BAR Meeting  
October 21, 2009

**ISSUE:** Permit to Demolish/Encapsulate  
**APPLICANT:** Jerry and Sara Kilkenny  
**LOCATION:** 500 North Columbus Street  
**ZONE:** CL/ Commercial Low Zone

BAR CASE #2009-0213 & 0208

Figure 9: Proposal – Rear Elevation (Door Removal/Brick Enclosure)

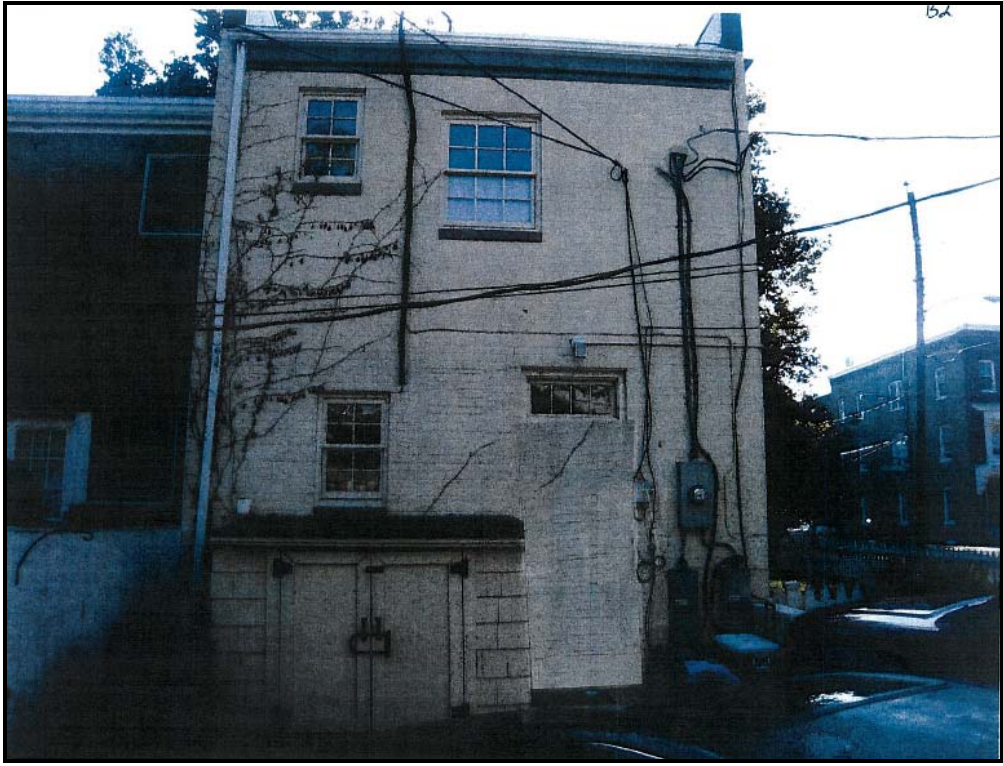
1. That the brick being utilized to fill in the rear door's opening be recessed a minimum of one inch from the existing wall surface.
2. That the proposed lattice trellis is fabricated from horizontal and vertical wood boards surrounded by a wood frame, rather than diagonal lattice as proposed.
3. That the proposed lattice trellis will be installed to disguise the door opening as well as the existing electrical meters located on the rear elevation.
4. The proposed lattice trellis will be free-standing.

Figure 14: 10/12/09 Revised Submittal: Proposed Conditions Drawing

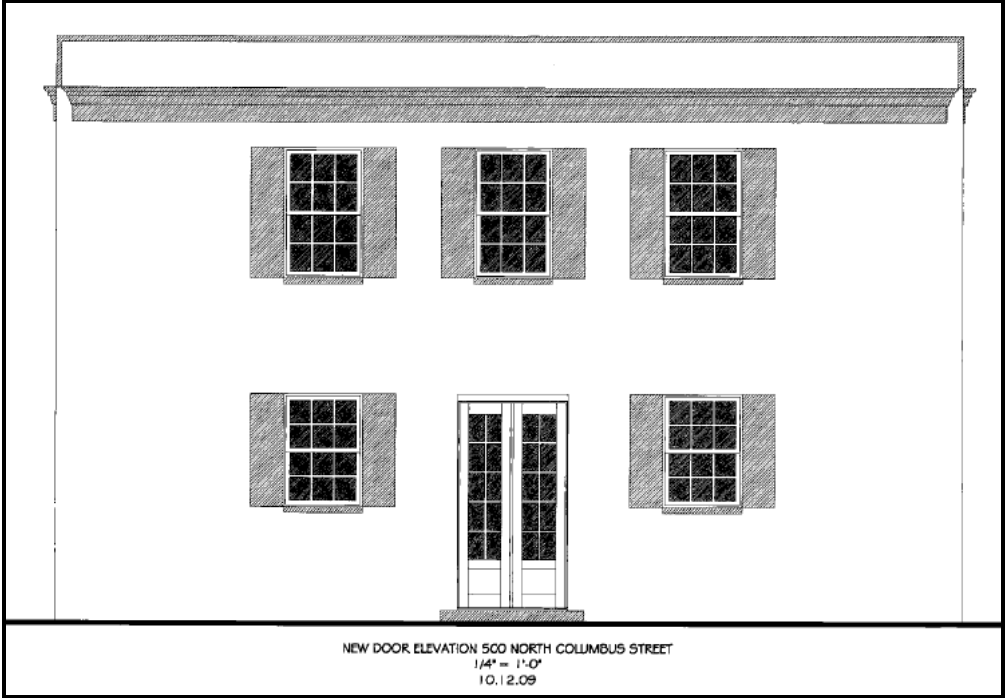
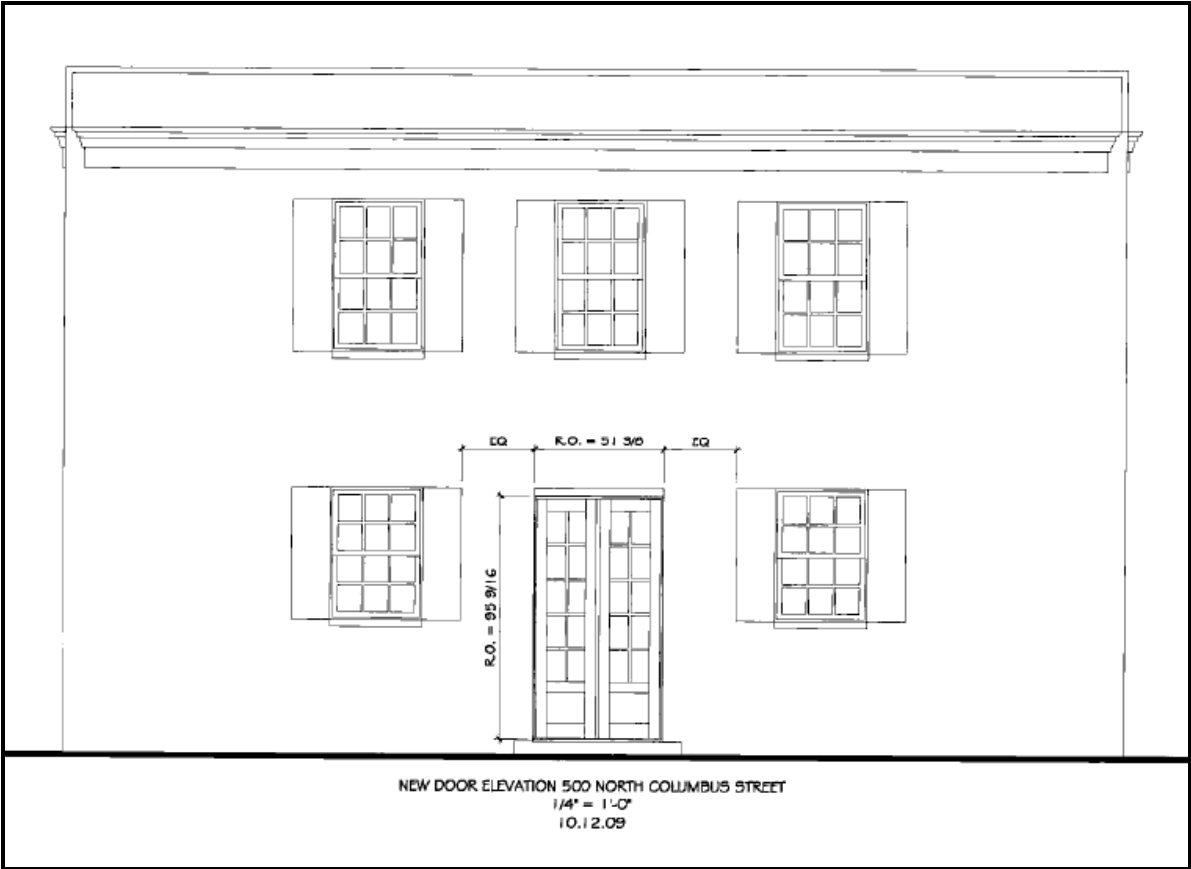
In response to the Board's request, the applicant commissioned an architect to draft an existing and proposed elevation drawing of the Oronoco Street (side) elevation. The proposed drawing depicts the applicant's proposal for this side elevation, which is the demolition of 32 square feet of wall surface and the installation of a double, ten-light French door (51-3/8"x 95-9/16"). The drawing also illustrates the corresponding proposed seven foot (7') long and two foot (2') wide, blue slate stoop. The proposal also includes the installation of an overhead light fixture to be centered above the proposed door.

In the opinion of Staff, none of the criteria are met for the proposed demolition. Staff finds the amount of proposed demolition small (thirty-two square feet) and based on the level of alterations the Board has previously approved for the subject property, the proposal to demolish a portion of the south elevation to allow a new door opening does not compromise the building's remaining architectural integrity. While Staff initially recommended that the area of demolition be reduced no greater than one door width and aligned with the existing first and second floor windows to maintain consistency with the side elevation's pattern of fenestration along Oronoco Street, the Board found at its October 7, 2009 hearing that the area of proposed demolition may be appropriate pending receipt of greater detail for the proposed door and opening.

Therefore, Staff recommends approval of the Permit to Demolish/Encapsulate application as submitted.
